**HAZARDOUS MATERIAL ABATEMENT
NEW FOUNDATIONS
RAISING EXISTING RESIDENCE
MINOR ALTERATIONS
CAROLE LaCROIX RESIDENCE
11 SIBLEY LANE (AKA 1 SIBLEY LANE)
EAST HAVEN, CONNECTICUT 06512**

ADDENDUM NO. 1191-2

Date: April 20, 2015

Application No. 1191
LAA Project No. 1524-21

RELOCATED GARAGE DOOR, DRIVEWAY & STAIR SKADT

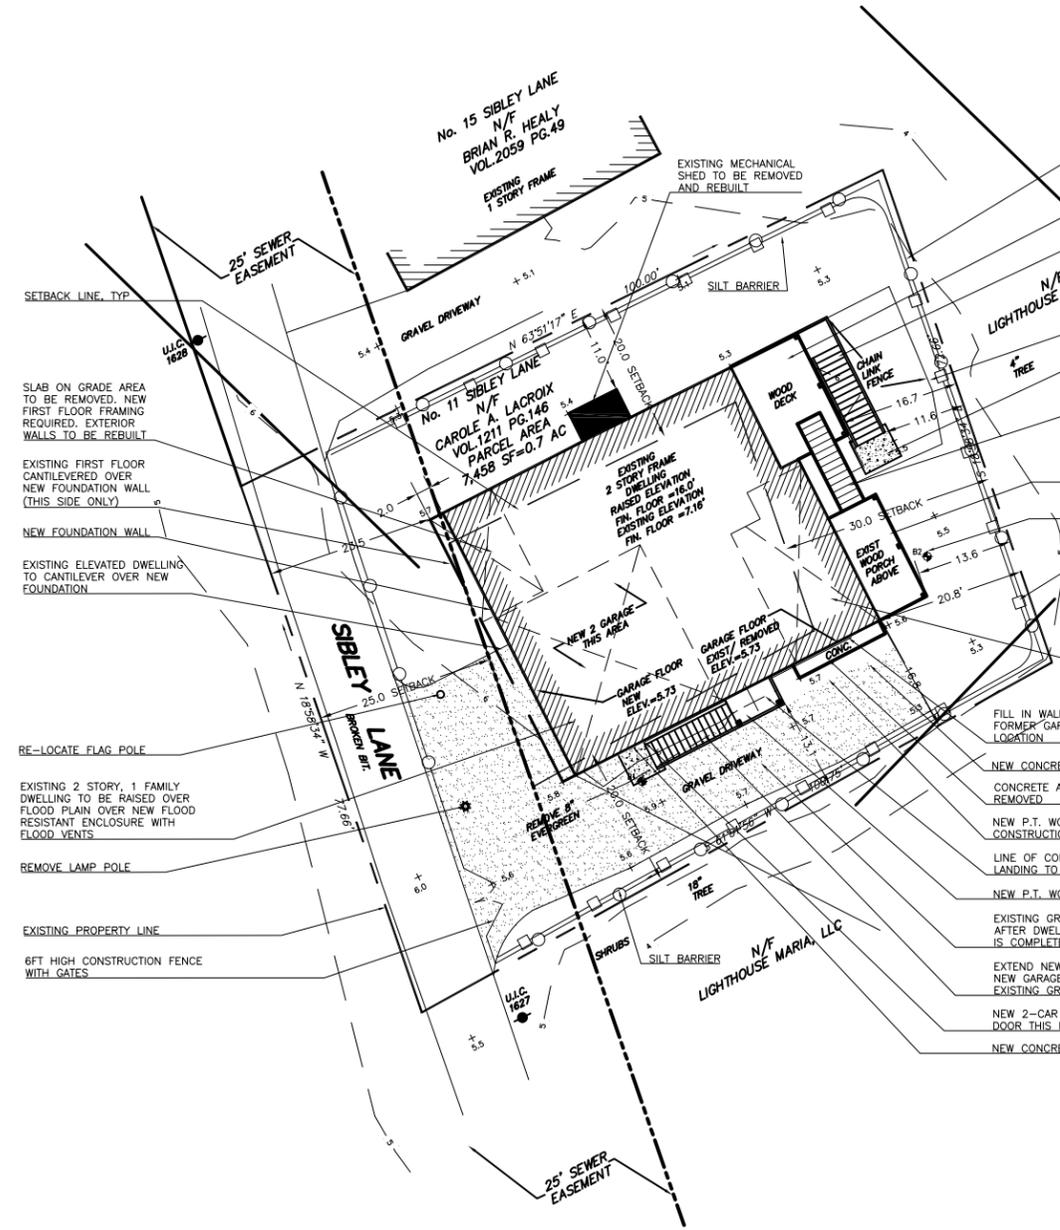
- A. DRAWING G-002 - Revise the following in accordance with attached SK-AD-1:
1. Relocate garage door, stair and conc. pad.
 2. Add gravel driveway on west side of building.
 3. Delete new gravel drive on south side of building.
 4. Relocate existing flagpole.
 5. Remove existing lamp pole.
 6. Relocate existing storage pod.
 7. Existing tree on south side of house to be removed by Owner.

- B. DRAWING A-101- Revise the following in accordance with attached SK-AD-1:
1. Relocate new garage door and light fixture above, from south side of building to west side.
 2. Relocate 2 flood vents from west side of building to south side.
 3. Relocate stair run on south side of building, redirected towards street.
 4. Revise garage floor pitch-redirect towards relocated garage door.
